**MEETING OF THE
PLANNING AND ZONING BOARD
QUASI-JUDICIAL PUBLIC HEARING**

March 20, 2018

**TOWN OF BAY HARBOR ISLANDS
COMMUNITY DEVELOPMENT
MEMORANDUM**

Subject: Site Development Plan Application - Revision
Driftwood Multifamily Residential Complex (35 DU)
9955 E. Bay Harbor Drive
Bay Harbor Islands Acct. No. SPR17-00001
MMPA Acct. No. 01-0702-1065

I PARKING COUNT DIAGRAM
SCALE: 1" = 30'-0"

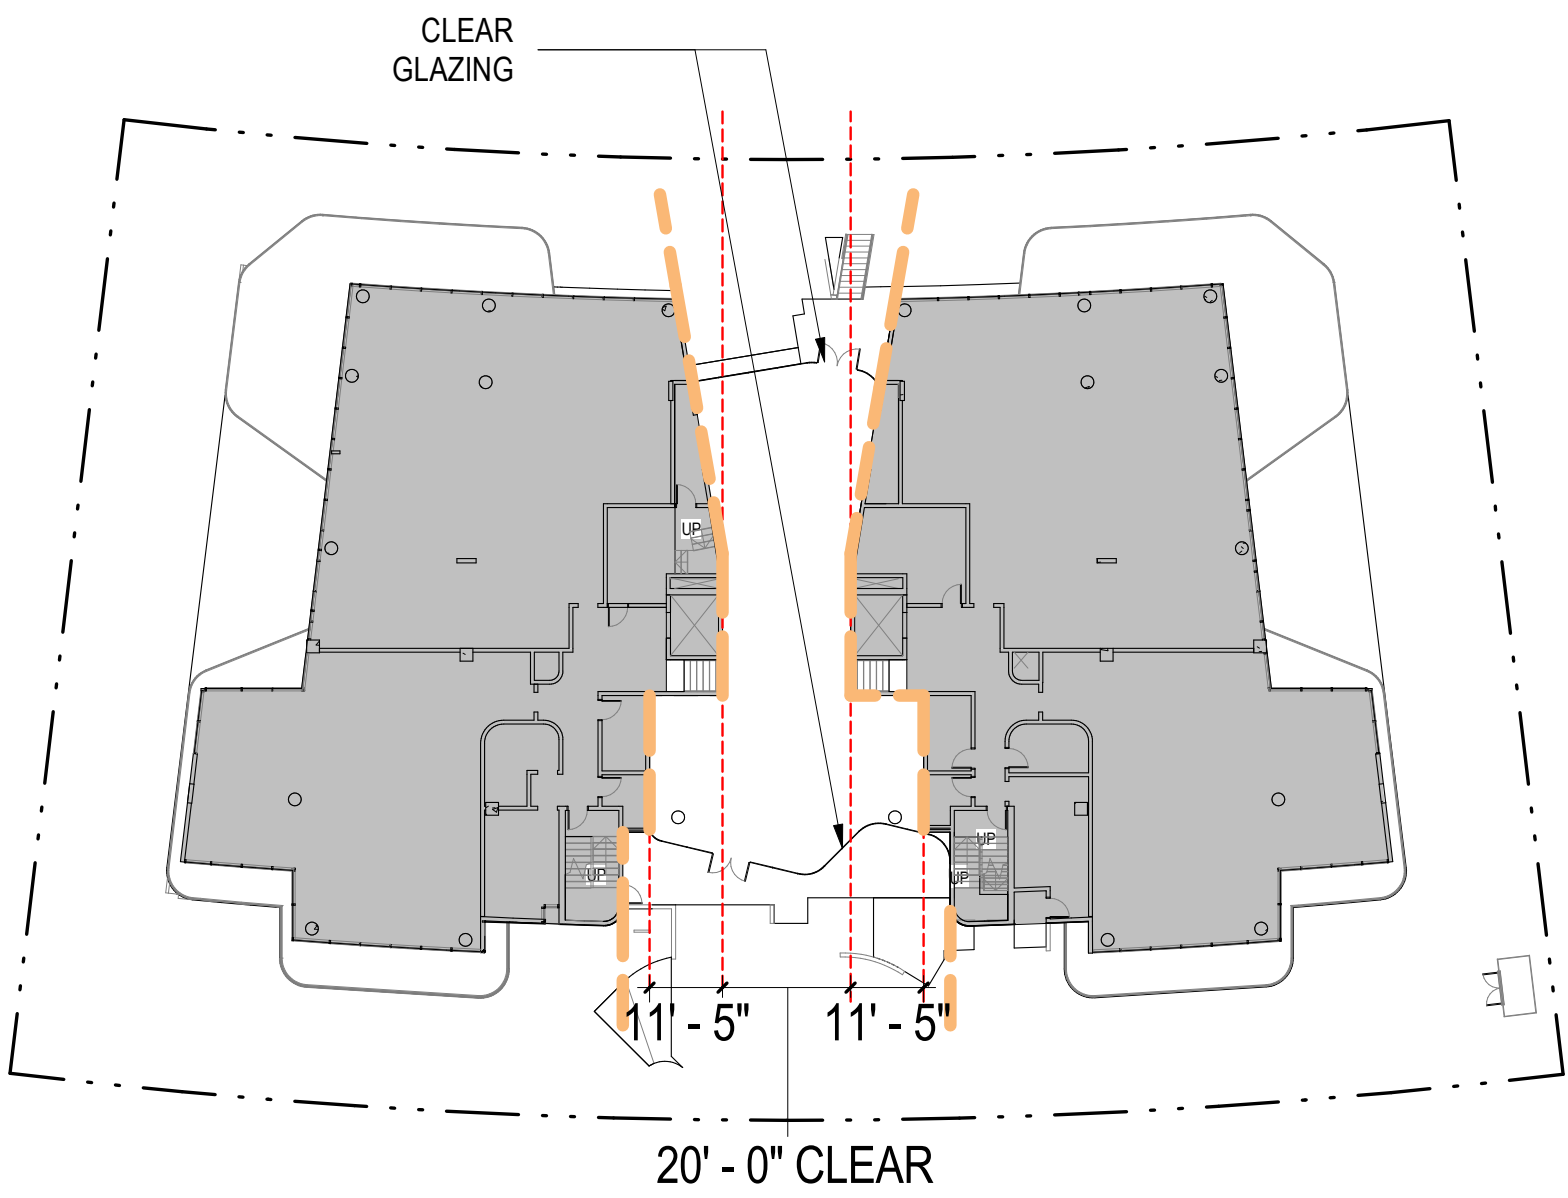
Based on 35 DU the Code requires at least 70 parking spaces. As there are three (3) lots at least three (3) guest spaces are required. The Code allows guest spaces to be a subset of the required parking spaces due to the small lot sizes, but the Town encourages more spaces. The site plan includes a total of 73 parking spaces. Of the 73 parking spaces provided, 68 are mechanical stacked parking, two (2) ADA spaces are at grade, and three (3) are guest spaces.

In addition to the guest spaces, a drop-off area near the lobby entrance is required, which the plan meets. One (1) of the guest parking spaces near the northern entry drive is not setback the required 10' and the drop-off area driveway is also not setback the required 10'. The Planning and Zoning Board has the discretionary authority to allow the guest spaces and the drop off area driveway to be less than 10' in a front yard (not less than 7'), as well as the mechanical parking system. The Code allows this discretion to accommodate the guest spaces / drop-off areas / loading due to the small lot sizes in the Town.

2 DETAIL - GUEST PARKING
SCALE: 1/4" = 1'-0"

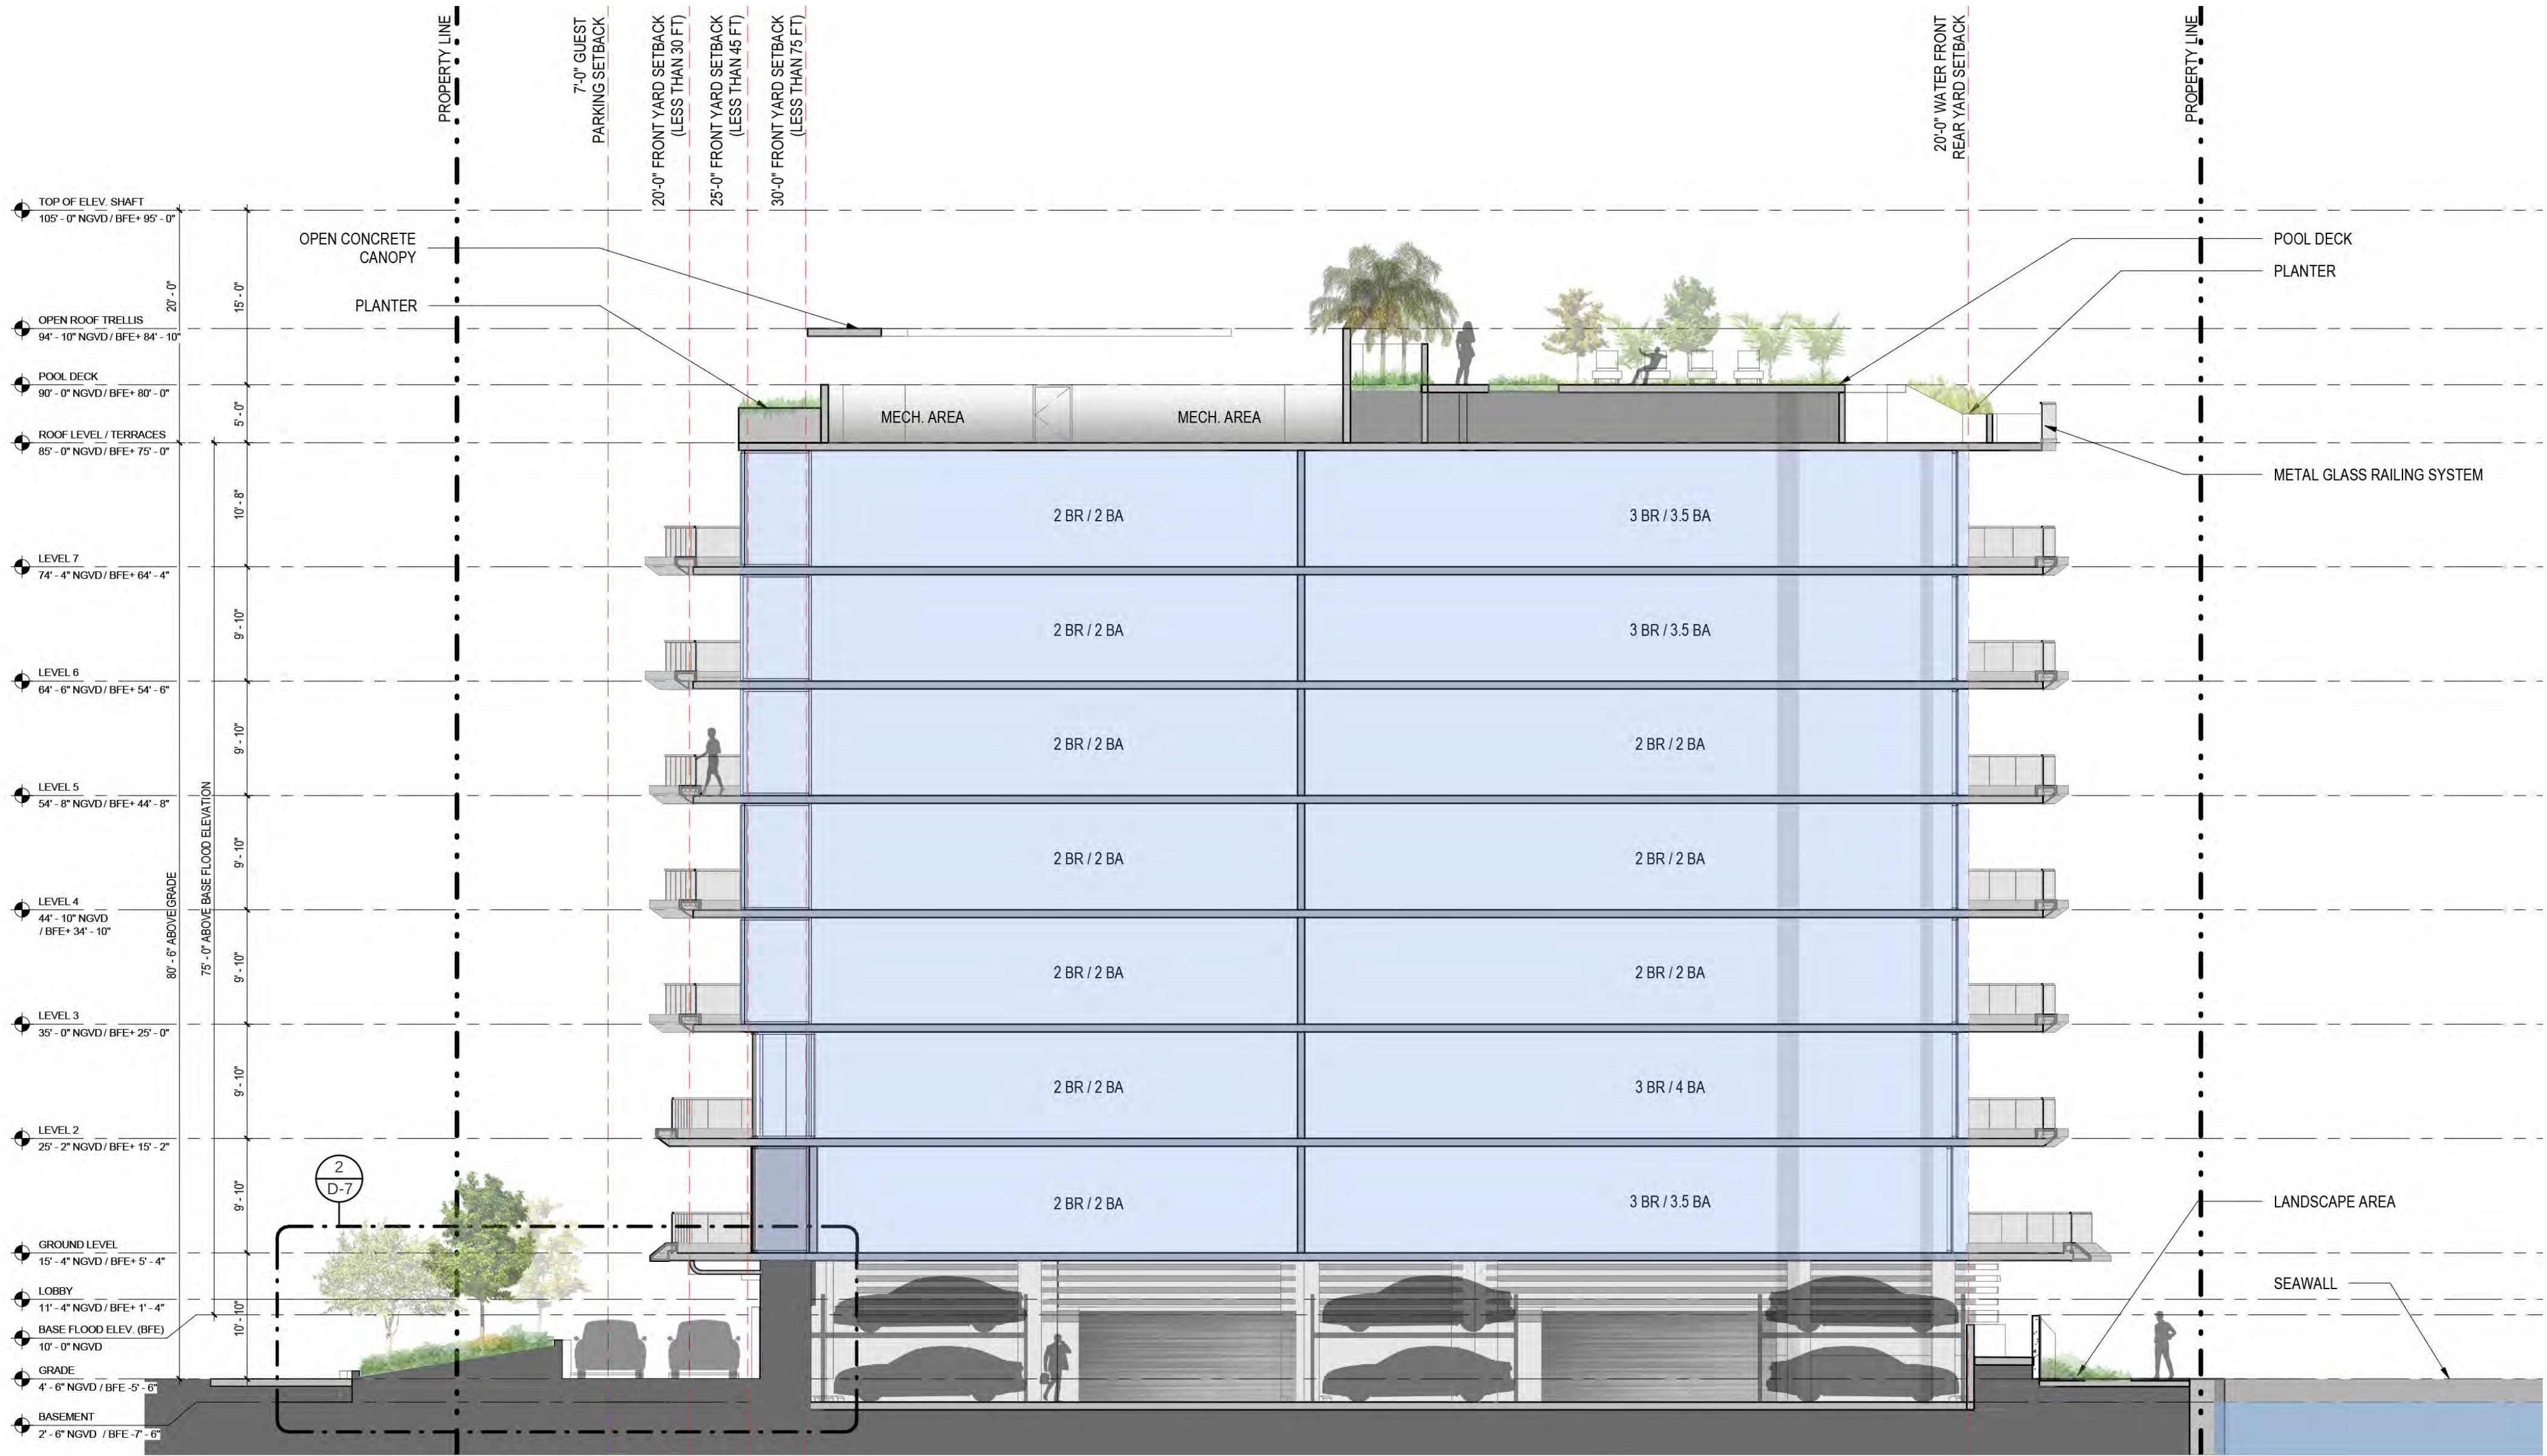
Additionally, to provide for more functionality to the site areas at the northeast and southeast corners where the previous design had proposed guest spaces are proposed to be a stabilized pervious landscape grid (turf block) that can be used for temporary parking / loading areas.
